1A & 1B VALLEY ROAD
59 - 63 TRAFALGAR AVENUE
LINDFIELD

SSD APPLICATION - DESIGN REPORT

APPENDIX AP6. RTS RFI RESPONSE

Eastern Facade Section 01 - Facing 3 Valley Road

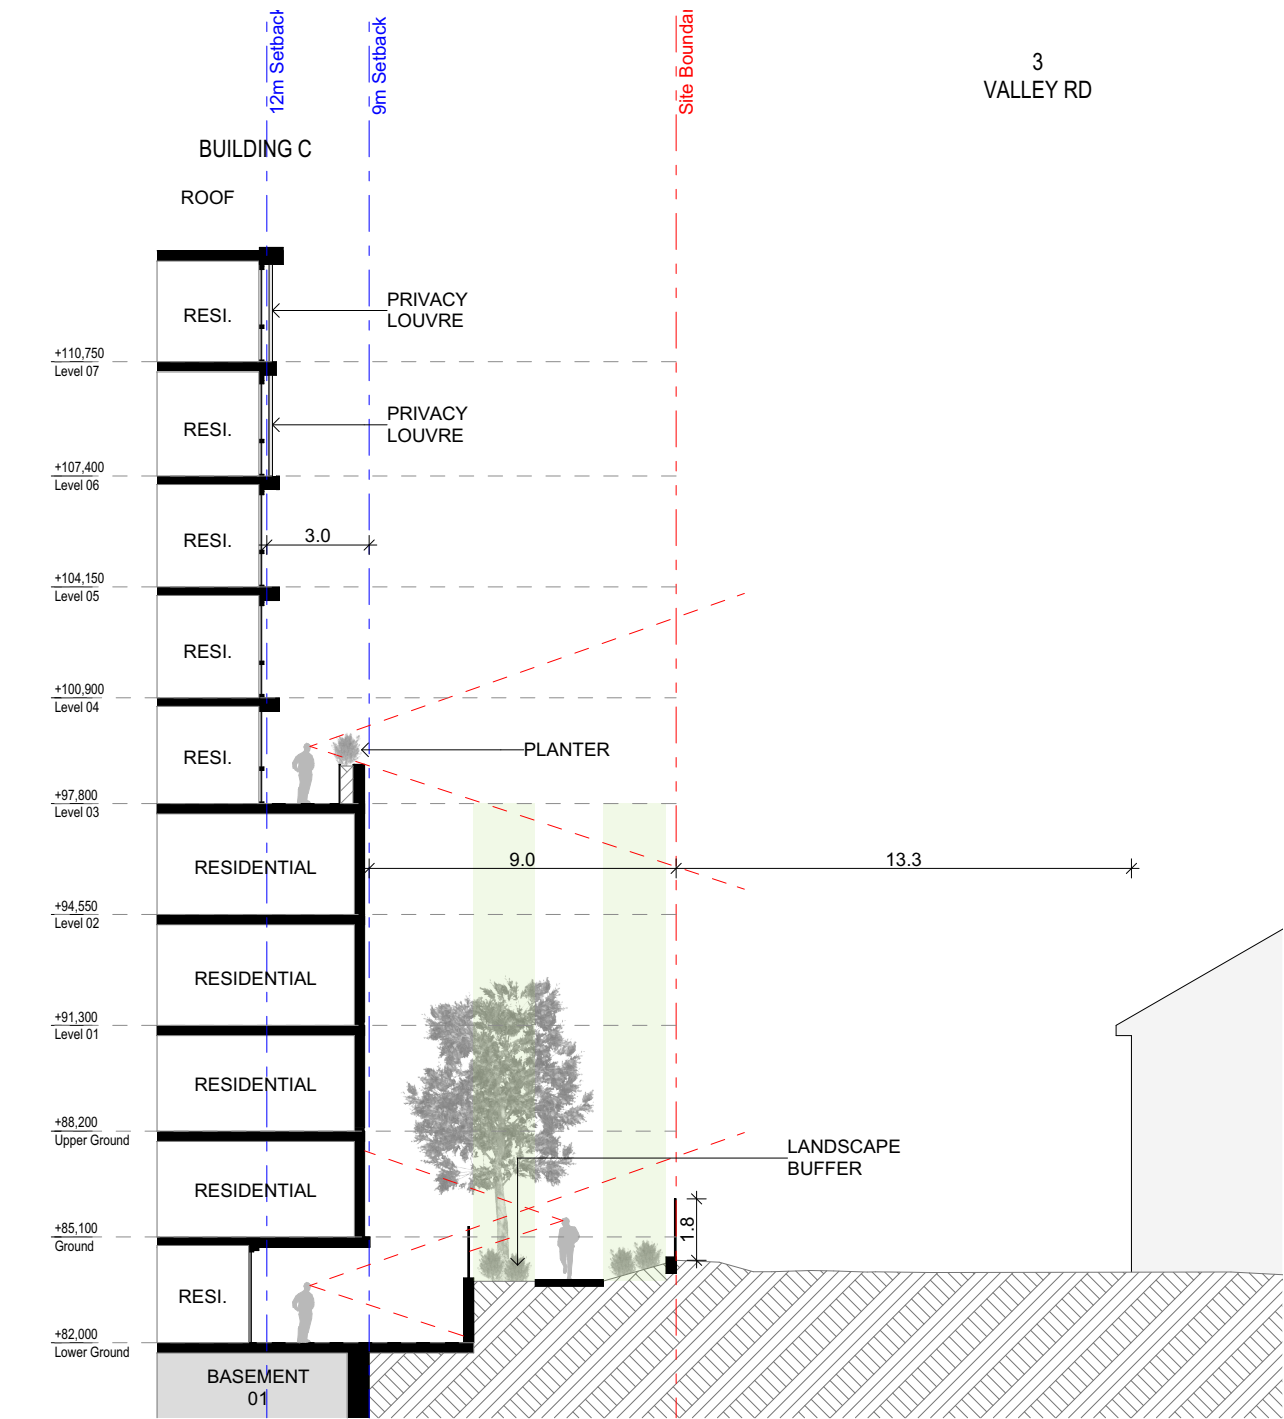
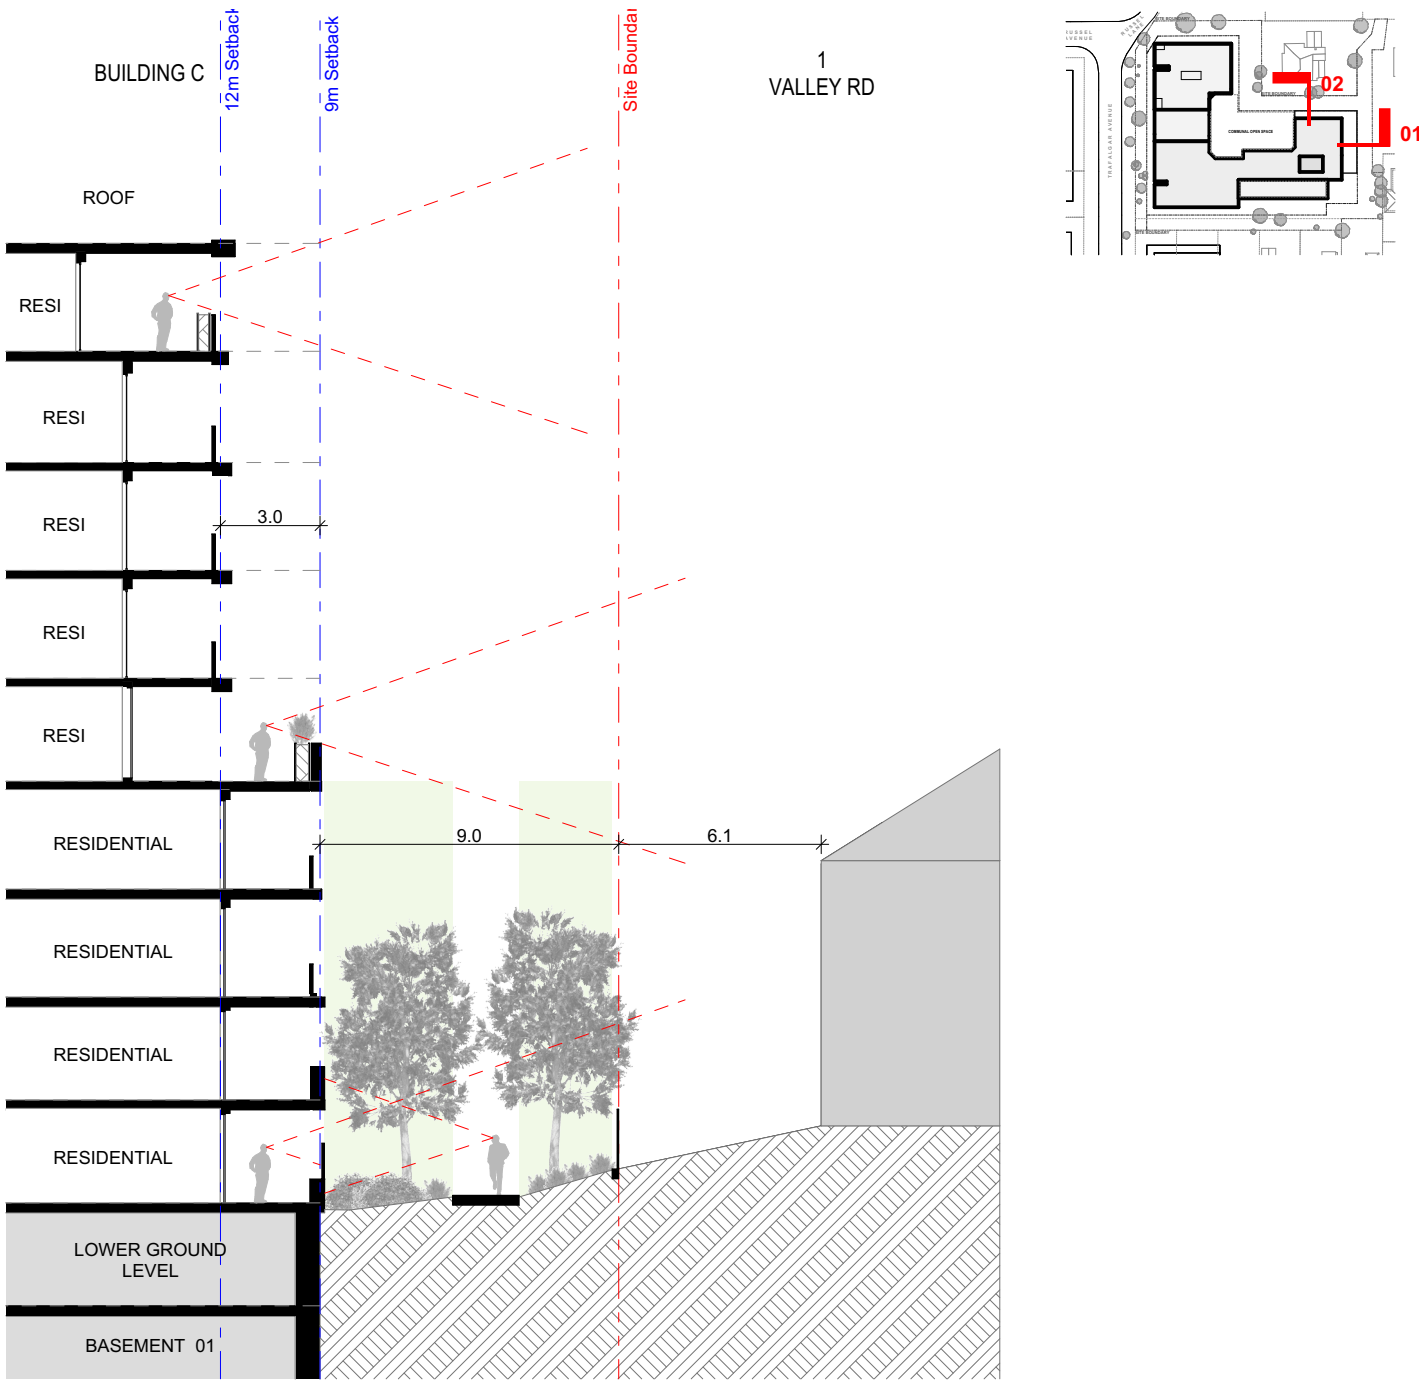
Level 5 setbacks show balcony in these zones. Justification to the ADG objective to be provided

Similar to the southern interface, the eastern and northern elevations fronting Valley Road adopt a consistent Level 5 condition. Along the western interface, the podium presents as partially five storeys in height in response to the site's slope and to maintain a consistent podium datum with the northern interface. Notwithstanding this, the podium continues to read as four storeys in scale due to the topography and architectural articulation.
